UNITED STATES PATENT AND TRADEMARK OFFICE

APPLICATION NO.	FILING DATE	FIRST NAMED INVENTOR	ATTORNEY DOCKET NO.	CONFIRMATION NO.
10/532,327	06/01/2005	Douglas Rawson-Harris	P/4732-2	9145

Office Action Summary	Application No. 10/532,327	Applicant(s) RAWSON-HARRIS, DOUGLAS	
	Examiner Adriana Figueroa	Art Unit 3637

DETAILED ACTION

FIG. 3

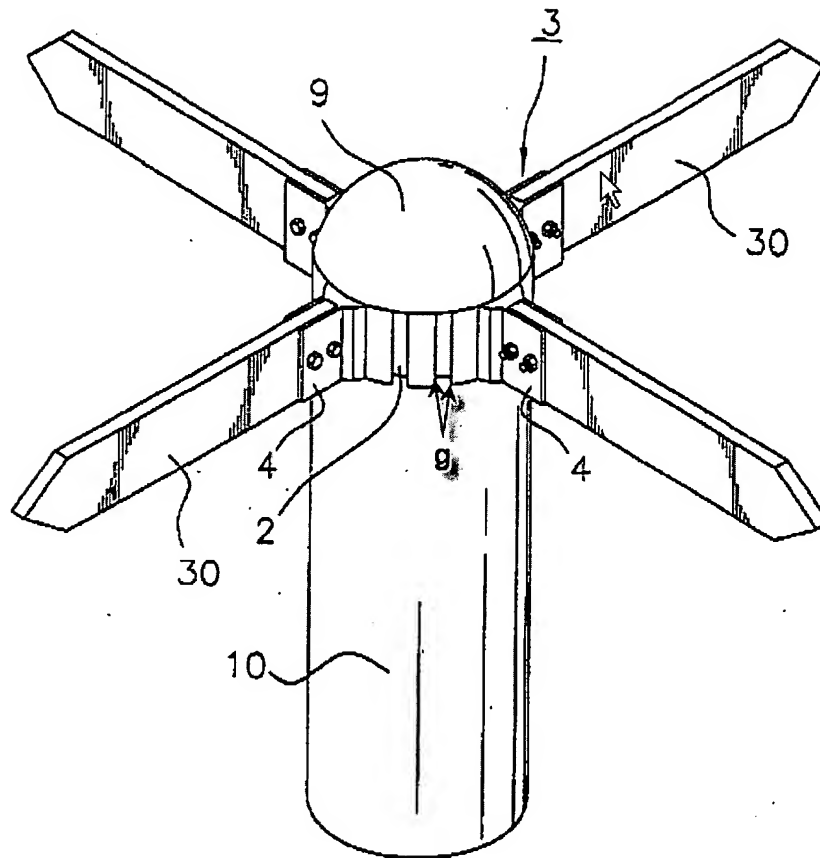
Regarding claim 1, Kim discloses at least one tubular column (10) having at least two longitudinally extending external tracks (2) integrally disposed therein, each of said external tracks having an internal groove (g) adjacent thereto, and at least one of said items is an arm (30) fixedly engaged with at least one of said internal grooves to prevent the rotation thereof relative to said tubular column (10), (annotated Figure 3).

Regarding claim 3, Kim discloses a reinforcing sleeve (7) is internally fitted along at least a portion of said tubular column (10), (Figures 2, 3).

Regarding claim 7, Kim discloses a deformable clamp block (3) is adapted to interconnect said at least one item (30) to said column (10) and said deformable clamp block engages with at least one of said external tracks (2) of said column, (Figures 2, 3).

Regarding claim 8, Kim discloses said deformable clamp block (3) is adapted to be relatively movable with respect to said column (10) to allow an angular adjustment of said at least one item (30) relative to the longitudinal axis of said column, (Figures 2, 3).

Regarding claim 9, Kim discloses said pole assembly further comprises a ventilated pole cap (9), (Figure 3).

Regarding claim 16, Kim discloses said at least one item (30) is a sign, (Figure 3), (Column 2, Lines 48-49). Kim does not disclose a streetlight, traffic signal, pedestrian signal, security camera or banner. However, Kim's sign is considered to be an obvious variation of a streetlight, traffic signal, pedestrian signal, security camera or banner and vice-versa.

FIG. 4

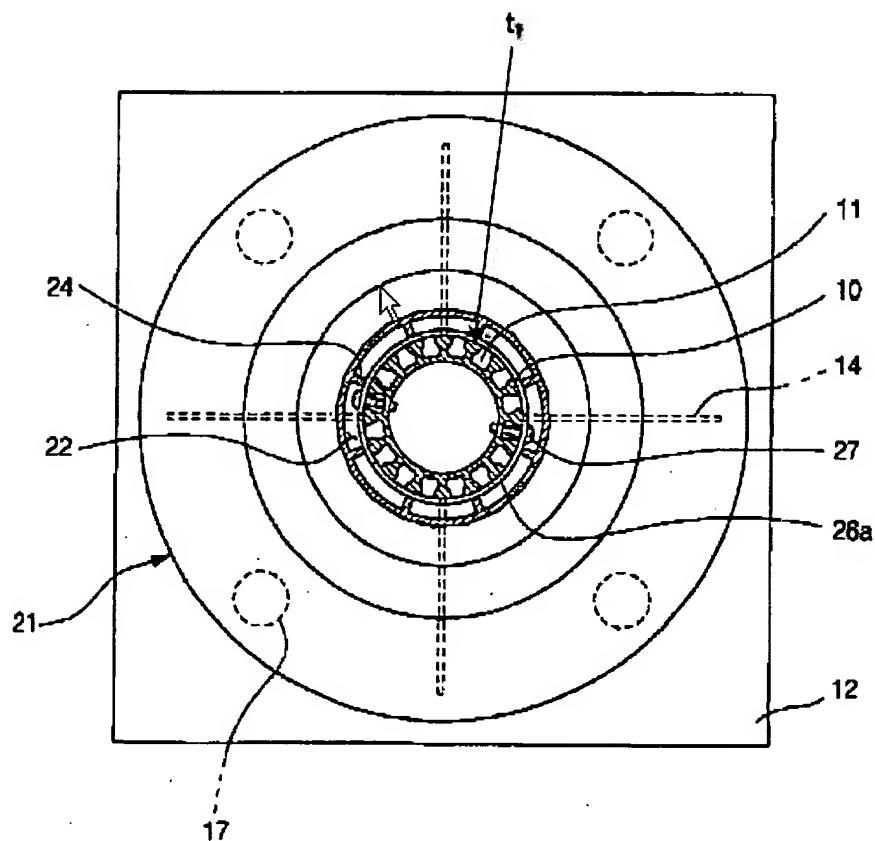
Regarding claim 1, Kim discloses at least one tubular column (10) having at least two longitudinally extending external tracks (t) integrally disposed therein, each of said external tracks having an internal groove (11) adjacent thereto, and at least one of said items is an arm (30) fixedly engaged with at least one of said internal grooves to prevent the rotation thereof relative to said tubular column (10), (Figure 1, annotated Figure 4).

McClasky (US 6,343,568)

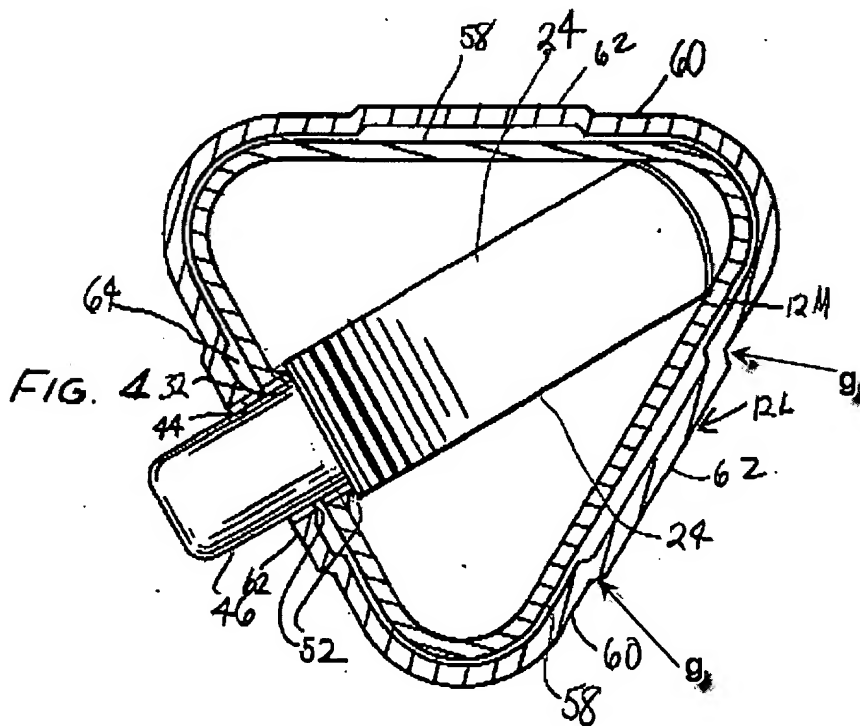
Regarding claim 1, McClasky discloses at least one tubular column (12L) having at least two longitudinally extending external tracks (62) integrally disposed therein, each of said external tracks having an internal groove (g) adjacent thereto, (Figures 1, annotated Figure 4). McClasky does not disclose an arm fixedly engaged with at least one of said internal grooves to prevent the rotation thereof relative to said tubular column. However, Kim teaches an arm (30) fixedly engaged with at least one of said internal grooves (11), (Figures 1, 4). Therefore, it would have been obvious to a person having ordinary skill in the arts at the time of the applicant's invention to modify the pole assembly of McClasky to include an arm as taught by Kim in order to provide a signboard.

Regarding claim 4, McClasky modified by Kim discloses a tubular section (12L') telescopically extending from said column (12L), (Figures 1, 5). McClasky does not disclose the tubular section being round. However, at the time the invention was made, it would have been an obvious matter of design choice to a person of ordinary skill in the art to have a round tubular section since such a modification would have involved a

Regarding claim 5, McClasky modified by Kim discloses a round tubular section (12L') has at least one internal track (62'), (Figure 5). McClasky does not disclose the tubular section being round.
